THE COMMONWEALTH OF MASSACHUSETTS
WATER RESOURCES COMMISSION
100 CAMBRIDGE STREET, BOSTON MA 02114

**Report of the Findings and Justifications of the
Water Resources Commission
Decision**

**Town of North Attleboro
Hillman Well
Interbasin Transfer Act**

Figure 2. Abbott Run Streamflow simulated for Hillman Well Site showing potential flow reductions from 1 MGD additional well withdrawal. Flows appear nearly identical.

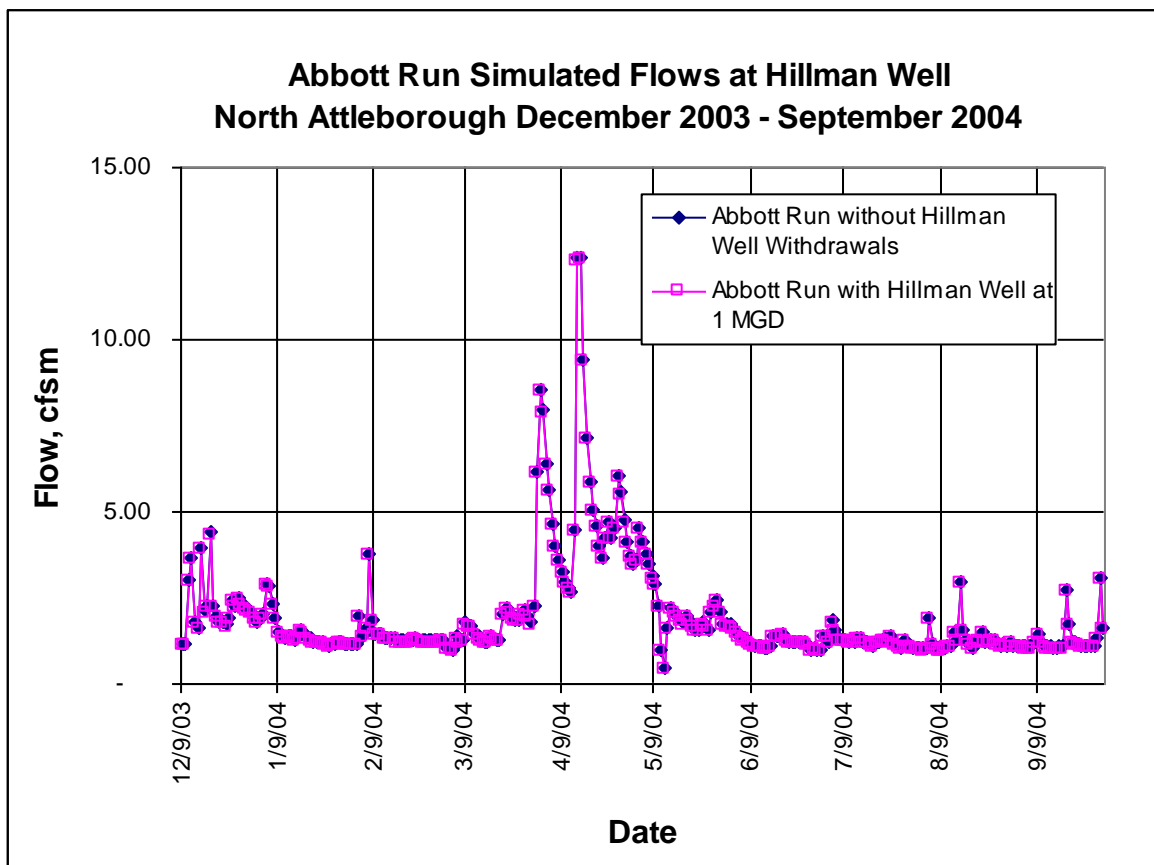
To illustrate the flow conditions near the Hillman Well, the data from the temporary USGS gage was scaled to the size of the Hillman Well drainage area (23.6 square miles / 26.9 square miles). The monthly withdrawals made from the Hillman Well during the gage period were added back into the flow, to simulate the flows that would have occurred in absence of the Hillman Well withdrawals. Flows at the Hillman Well site were simulated to range from 11 cfs to 293 cfs with an average of 46 cfs and a median of 32 cfs. The Hillman Well safe yield of 1.0 MGD (1.55 cfs) was then subtracted from the flow for each day to evaluate the impacts of the maximum withdrawal rates on the estimated streamflow. It was therefore estimated that the Hillman Well safe yield (1 MGD) withdrawal would have represented between 0.53% and 14% of the river flows at the well site, with an average of 4.36% for the gaged period of December 2003 to September 2004. Flows at the well site, even with the reduction for maximum well withdrawal, would have ranged between 0.41 cfs/m and up to 12.33 cfs/m. Figure 2 depicts the hydrograph from this period with the Abbott Run simulated flow and the reduced flow superimposed. The flows are nearly indistinguishable. Figure 3 shows the same data with only the lower flows between May 1 and September 30, to illustrate the summer flow reductions. During the summer months, the flows generally remained near or above 1 cfs/m throughout the monitoring period. These flows are considered adequate for instream flow needs in Abbott Run, and the impacts of the well withdrawals acceptably minor.
